Transportation Impact Study Update

BROWLANDS RESIDENTIAL DEVELOPMENT

801, 820, 855, 865 and 870 Scenic Drive
HAMILTON, ONTARIO

May 2022
Project No: NT-18-048

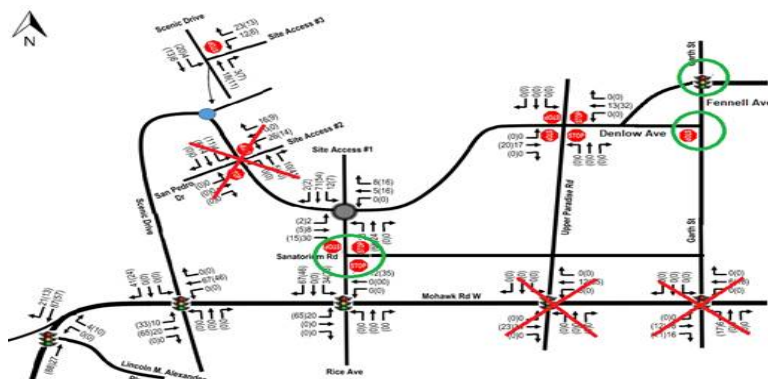
13. Based on the comments above the study area shall be revised to eliminate 3 intersections and add 3 intersections to be analysed based on anticipated impacts of development generated traffic. The following intersections will be required in a future submission:
 - a. Garth Street at Scenic Drive/ Fennell Avenue (City to provide TMC)
 - b. Garth Street at Denlow Avenue (City to provide TMC)
 - c. Sanatorium Road/ Rice Avenue at Sanitorium Road (TMC required)

The diagram below illustrates the revised study area for the resubmission, including the intersections no longer required in the analysis:

Response: Noted. These intersections have been added into the analysis. The analysis indicates that these intersections are expected to operate at acceptable levels of service and be able to accommodate the proposed development traffic without any physical improvements.

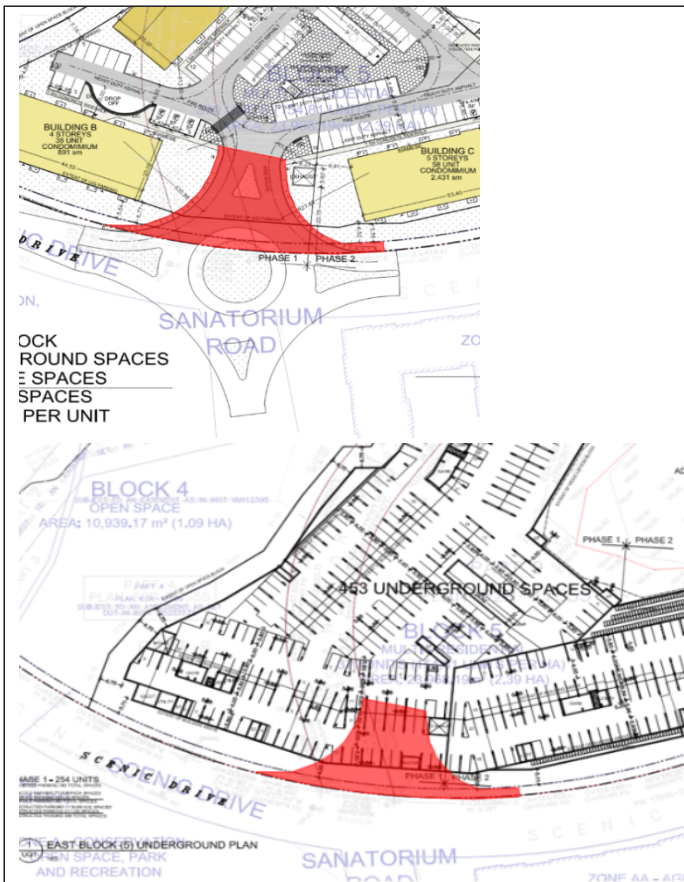
| <p>24. A detailed design of the roundabout at Scenic Drive at Sanatorium Road/ Site Access must be completed to the satisfaction of the Manager, Transportation Planning; Manager, Development Approvals, Planning and Economic Development and Director, Engineering Services, Public Works to determine the ultimate right-of-way dedication requirements. The roundabout may require right-of-way exceeding typical values. The design shall incorporate a planned 3.5 metre multi-use trail, planned to run on the north side of Scenic Drive.</p> <p>25. As required, the right-of-way dedication of approximately 3.0 metres is shown on the site plan along Scenic Drive. The right-of-way for Scenic Drive is required to be 26.213 metres as per the Official Plan.</p> <p>26. A detailed design of the roundabout at Scenic Drive at Sanatorium Road/ Site Access must be completed to the satisfaction of the Manager, Transportation Planning; Manager, Development Approvals, Planning and Economic Development and Director, Engineering Services, Public Works to determine the ultimate right-of-way dedication requirements. The roundabout may require daylighting triangles that exceed typical dedications for Collector Roads. Neither the parking garage, or any objects or structures cannot encroach into the municipal right-of-way. The encroachment is shown below in red.</p> | |
